Addendum 01

Date: May 10, 2023
Project: UHN Cardiac Care Unit Renovation
Project Number: N662330007

SUGGESTED HOARDING PLAN

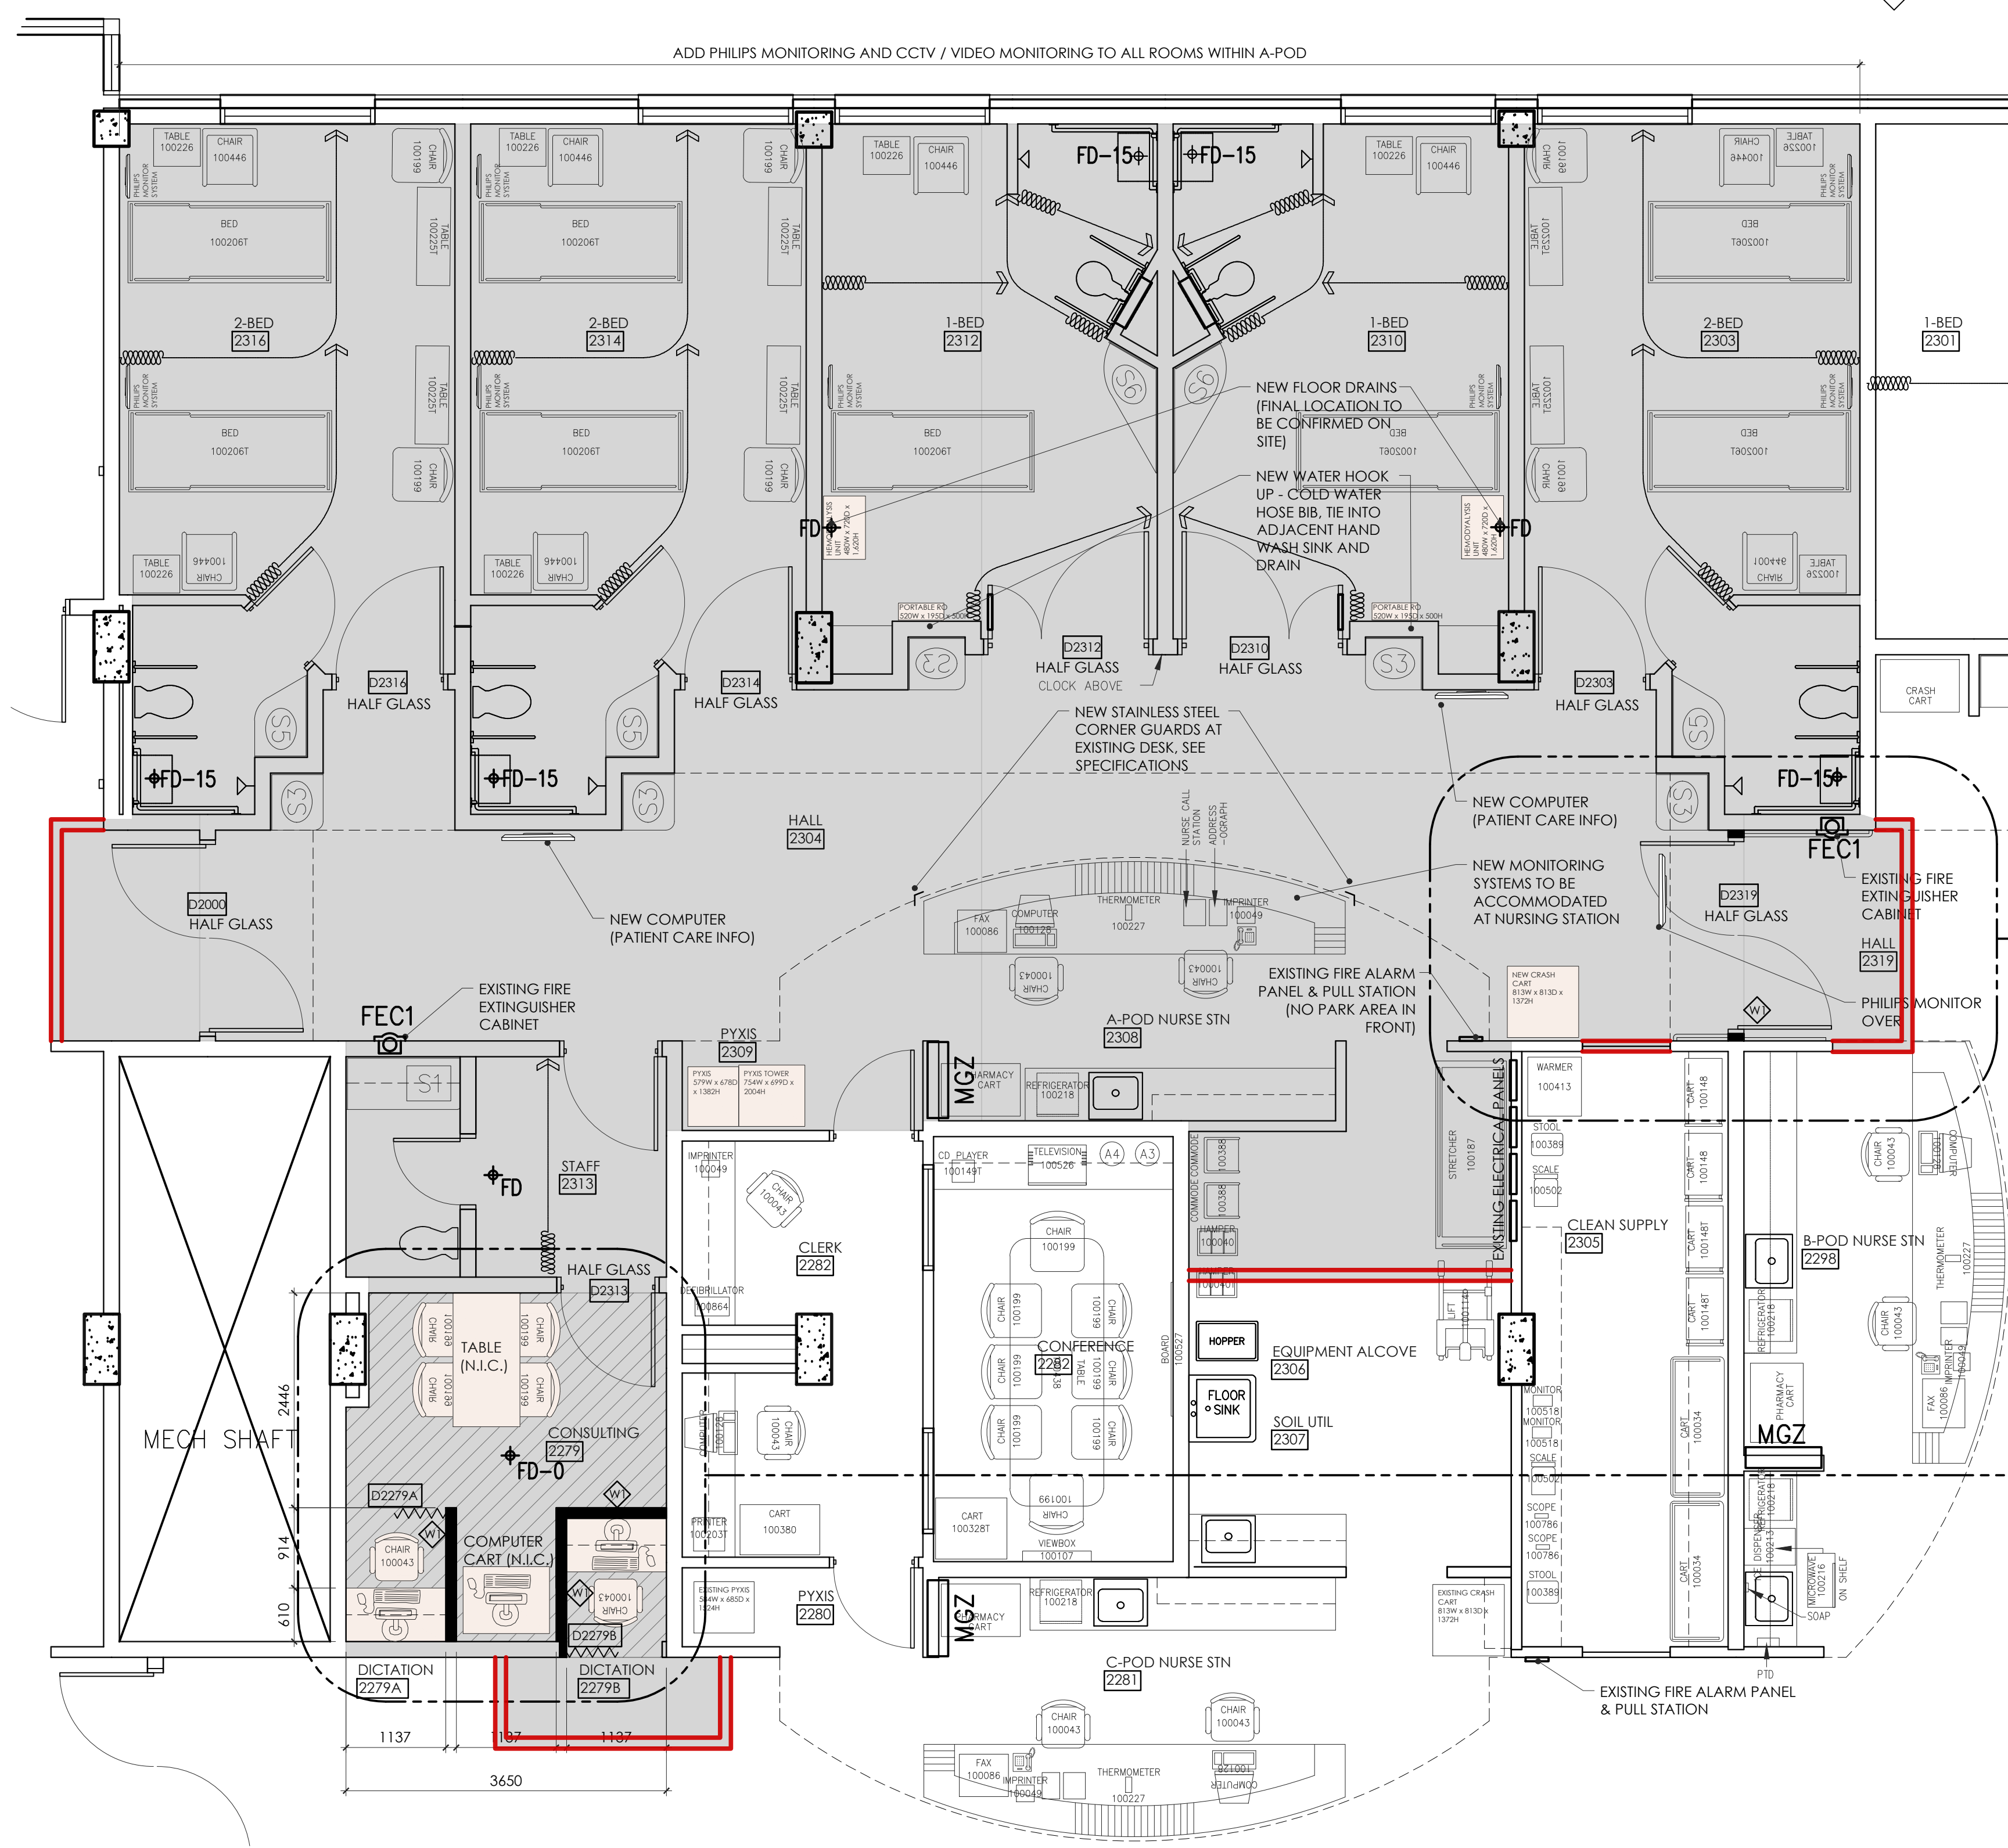
1. See attached suggested hoarding plan.
